**Notes from a public meeting on the  
WestConnex Stage 3 (M4-M5 Link)  
Environmental Impact Statement (EIS)  
held at Centurion Lounge, Leichhardt Oval  
6:30-8:30pm Wednesday 4 October 2017**

**Attention:** Director, Infrastructure Projects, Planning Services Department of Planning and Environment, GPO Box 39, Sydney, NSW, 2001

Leichhardt Against WestCONnex (**LAW**) is a community group formed in August 2016 in response to unconfirmed reports that Sydney Motorway Corporation (**SMC**) had earmarked 7 Darley Road, Leichhardt (the now Dan Murphys site) as a possible mid-tunnel construction ('dive site') for the M4-M5 Link, WestConnex. As a community very familiar with the constraints of the site and its history of traffic accidents and fatalities, and unable to obtain any information from the Government about this proposal, we formed a community group to obtain information and communicate to the Government our serious concerns with this proposal and the Westconnex project as a whole. LAW is not affiliated with any political party and is run by volunteers, without government funding. LAW has over 1,000 members from the Leichhardt and surrounding area.

Figure 10-16 Highly noise affected residential receivers - Darley Road

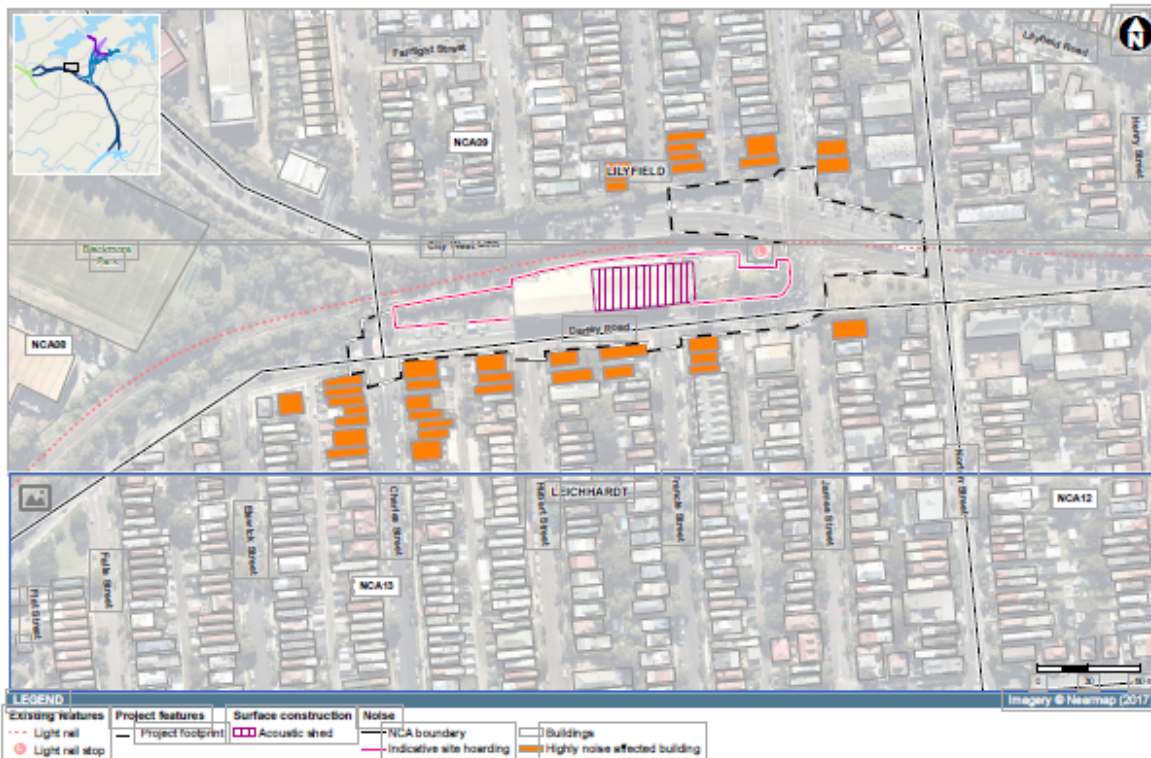
SMC's response does not acknowledge this and does not refute Jim Holt's conclusion that residents will be impacted. The response, like the proponent's EIS, fails to acknowledge the true impact of the Darley Road civil and tunnel site (C4) at Leichhardt. You do not need to be an acoustic engineer to know that truck and dogs are very noisy and that local residents will be impacted greatly, especially those close to where trucks will be accelerating and decelerating. Darley Road, Leichhardt is not currently experiencing 14 truck and dog movements an hour during peak time stated in the EIS and an unknown (but presumably greater) number of truck movements within off peak construction hours. This is a truck movement every 3-4 minutes during peak. Assuming that

Figure 6-20 Indicative Darley Road civil and tunnel site (C4) layout

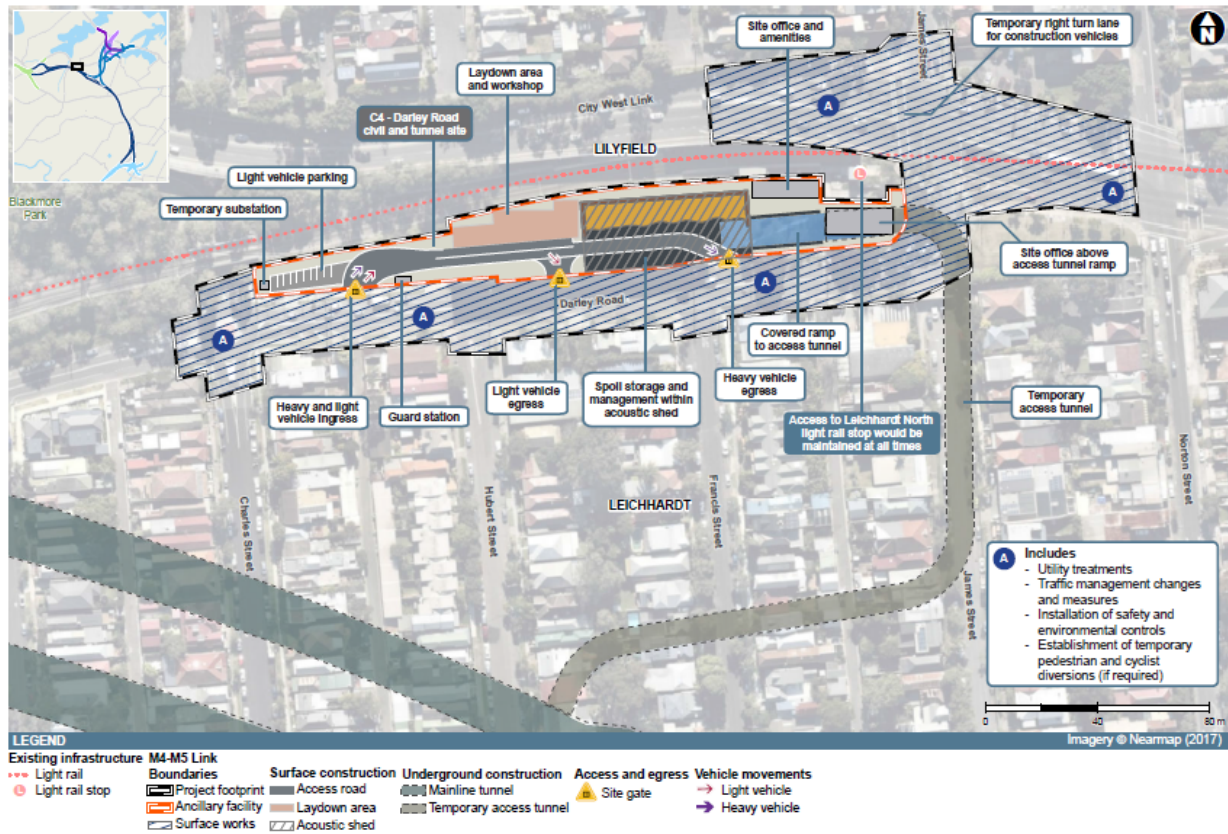
- The proponent has not provided a clear plan for measures that will be taken to minimise noise impacts from work within and outside of standard construction hours at the Darley Road civil and tunnel site (C4) at Leichhardt.
- The proponent has failed to take account of the fact that the demolition of the Dan Murphys building will remove a significant barrier to traffic noise from the City West Link. This will mean increased traffic noise impacts to the residents of Darley Rd, Francis St, Hubert St and Charles Street.

- The proponent has failed to take account of the noise impact of fully laden spoil haulage trucks exiting the Darley Road civil and tunnel site (C4) at Leichhardt driving up the very steep blind turn at the intersection with the City West Link. The RMS should install noise measuring equipment and monitoring cameras at this location to measure noise from heavy vehicles and identify vehicles whose noise exceeds the applicable Australian standard.

- The proponent has failed to take account of the noise impact of spoil haulage trucks using air brakes on the descent down Darley Rd off the City West Link. Heavy vehicle drivers should avoid using exhaust brakes, engine compression or 'jake' brakes near residential areas and noise-sensitive areas such as hospitals and schools, unless they are necessary for safety reasons. RMS should implement noise limits from engine compression brakes and should use roadside noise 'cameras' as an aid to enforcement as vehicles emitting engine compression brake noise might affect nearby communities.

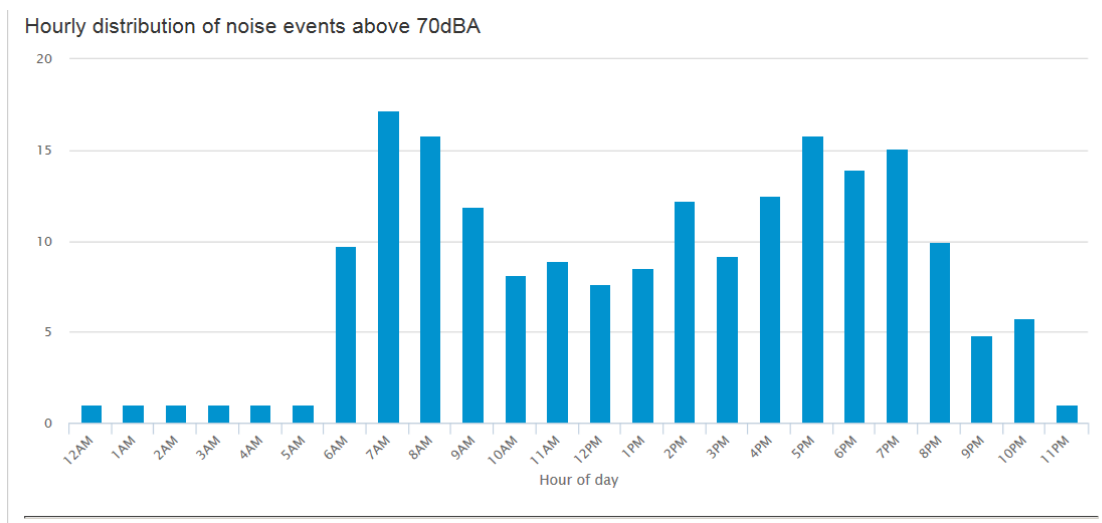
We object to the EIS because the proponent provides that spoil handling works within the acoustic shed will take place for the duration of the construction phase which could be up to two to three years duration, yet there is no clear plan for measures that will be taken to minimise noise impacts.

We object to the Darley Road civil and tunnel site (C4) on the basis that there is no clear plan in the EIS for measures that will provide the maximum possible level of mitigation from noise impacts. We also object because there is no clear plan for remedies available to residents who are impacted.

Figure 6-28 Indicative spoil haulage route – Darley Road civil and tunnel site (C4)

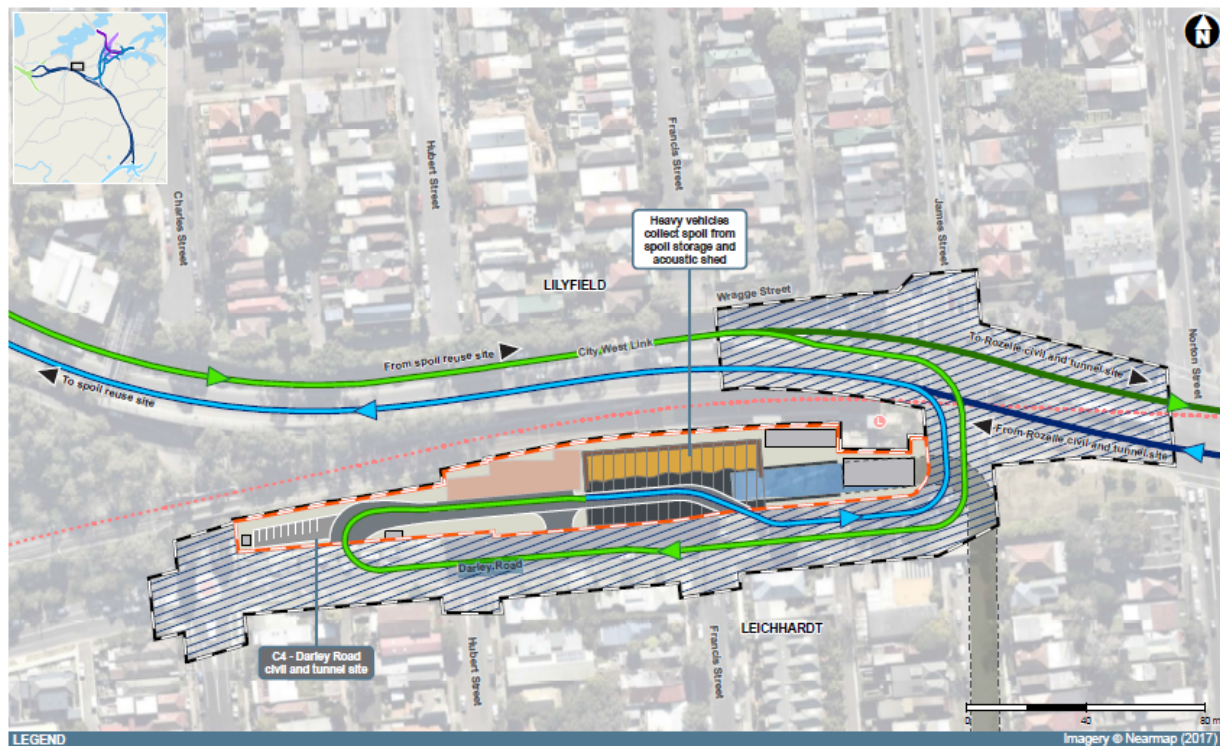
Peter Jones (SMC) has on many occasions made public representations to the community that his plan is to stage trucks from the port and eventually when possible to have them arrive and depart from the site underground when a tunnel is established between Leichhardt and the M4 East. He has also stated that loading of spoil would take place underground at this time. He has recently told LAW of his new plan to load trucks from a ramp off the City West Link by means of a hopper conveyor which would pass over the Light rail station delivering spoil into silos below which trucks would pull up to receive their load. The laden trucks would then travel west bound along the city west link. **None** of this plan is detailed in the EIS.
